Access Compliance Report

Public Rights-of-Way

Intersection ID: N/A	Main Street: YORK_CENTER	Cross Street: N/A	Location: SW
ADA ID: 56B94E8F5A27	Ramp Type: PerpDiag	Initial Pass/Fail: Fail	Overall Compliance: No
Codes/Mitigation Info/Possible Solution		Field Measurements/Component Compliance	
Severity Score: 12.5

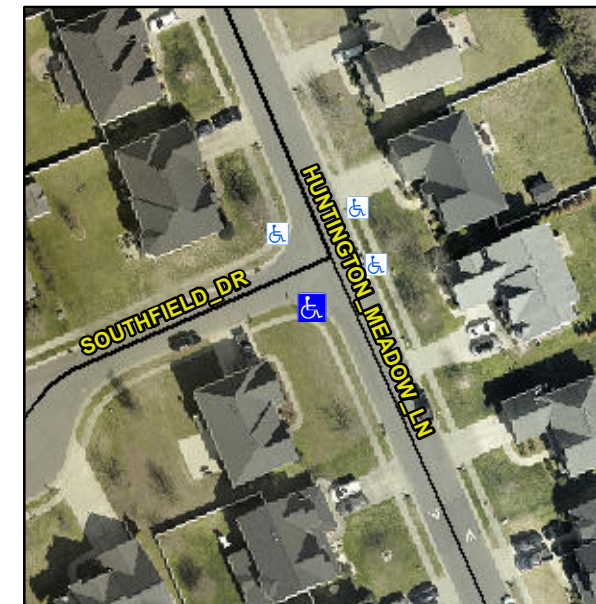
R304.2.2

Compliance	Description	Data	Compliance	Description	Data
N/A	Ramp Length (in)	47.0	No	Ramp Slope (%)	10.2
Yes	Ramp Width (in)	48.0	Yes	Ramp XSlope (%)	1.5
N/A	Flare Type LT	N/A	N/A	Flare Type RT	N/A
N/A	Flare Slope LT (%)	N/A	N/A	Flare Slope RT (%)	N/A
N/A	Flare Traversable LT?	N/A	N/A	Flare Traversable RT?	N/A
N/A	Landing Length (in)	N/A	N/A	DWS Provided?	N/A
N/A	Landing Width (in)	N/A	N/A	DWS Contrast?	N/A
N/A	Landing Slope (%)	N/A	N/A	DWS Length (in)	N/A
N/A	Landing X Slope (%)	N/A	N/A	DWS Full Width?	N/A
N/A	Landing Curb? (Y/N)	N/A	N/A	DWS Offset (in)	N/A
N/A	Shared Landing?	N/A			
N/A	Gutter Ponding?	N/A	N/A	Gutter Slope (%)	N/A
N/A	Gutter Lip Ht (in)	N/A	N/A	Gutter X Slope (%)	N/A
N/A	Painted X Walk1?	No	N/A	Painted X Walk2?	No
	X Walk 1 Direction	To E		X Walk 2 Direction	To N
N/A	X Walk 1 Width (in)	N/A	N/A	X Walk 2 Width (in)	N/A
	X Walk 1 Slope (%)	3.1		X Walk 2 Slope (%)	2.1
	X Walk 1 X Slope (%)	0.5		X Walk 2 X Slope (%)	0.9

Remove & Replace Curb Ramp With Two New Directional Ramps or Equivalent.
